May 6, 2021

Product Change Notice - Weep hole reduction from 6 to 4 on window widths 60" and larger

8800BT shown with 4 weep holes for widths larger than 60".

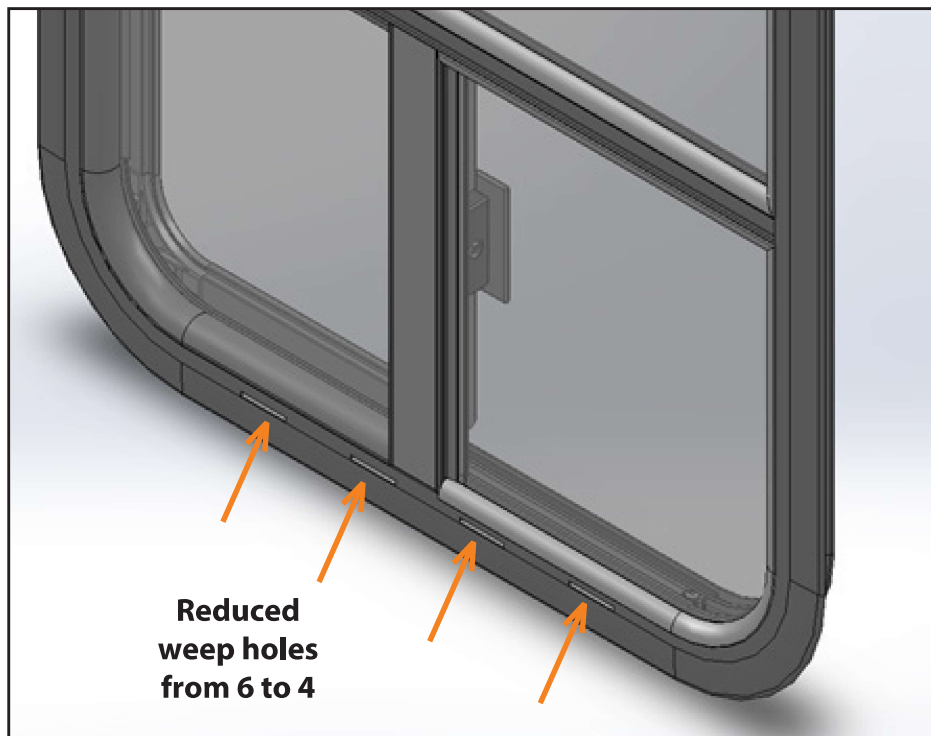
Lippert will be reducing the number of weep holes from 6 to 4 for windows larger than 60" wide. We have determined through internal testing that this change will minimize potential water entry points while maintaining more than sufficient water management. Additionally, reducing the weep hole count will help align our building processes to match other window series within the company.

There is no change in installation or operation with the weep hole reduction. The change will be made on a running basis, starting on or around June 5.
